Access Compliance Report

Public Rights-of-Way

Intersection ID: 30402	Main Street: WOODLAWN_RD	Cross Street: PARK_RD_SHOPPING_CENTER_DR	Location: SE
ADA ID: 582B52A57848	Ramp Type: PerpDiag	Initial Pass/Fail: Fail	Overall Compliance: No
			Severity Score: 21.25

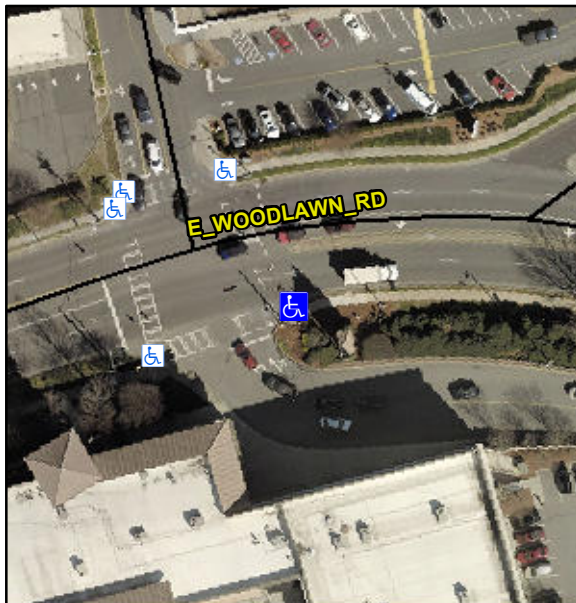
R304.5.1, R304.5.3

Compliance	Description	Data	Compliance	Description	Data
N/A	Ramp Length (in)	97.0	Yes	Ramp Slope (%)	8.0
No	Ramp Width (in)	46.5	No	Ramp XSlope (%)	6.1
N/A	Flare Type LT	N/A	N/A	Flare Type RT	N/A
N/A	Flare Slope LT (%)	N/A	N/A	Flare Slope RT (%)	N/A
N/A	Flare Traversable LT?	N/A	N/A	Flare Traversable RT?	N/A
N/A	Landing Length (in)	N/A	N/A	DWS Provided?	N/A
N/A	Landing Width (in)	N/A	N/A	DWS Contrast?	N/A
N/A	Landing Slope (%)	N/A	N/A	DWS Length (in)	N/A
N/A	Landing X Slope (%)	N/A	N/A	DWS Full Width?	N/A
N/A	Landing Curb? (Y/N)	N/A	N/A	DWS Offset (in)	N/A
N/A	Shared Landing?	N/A			
N/A	Gutter Ponding?	N/A	N/A	Gutter Slope (%)	N/A
N/A	Gutter Lip Ht (in)	N/A	N/A	Gutter X Slope (%)	N/A
N/A	Painted X Walk1?	Yes	N/A	Painted X Walk2?	Yes
	X Walk 1 Direction	To NW		X Walk 2 Direction	To W
N/A	X Walk 1 Width (in)	105.0	N/A	X Walk 2 Width (in)	112.0
	X Walk 1 Slope (%)	0.2		X Walk 2 Slope (%)	5.2
	X Walk 1 X Slope (%)	3.9		X Walk 2 X Slope (%)	3.9

Remove & Replace Curb Ramp With Two New Directional Ramps or Equivalent.
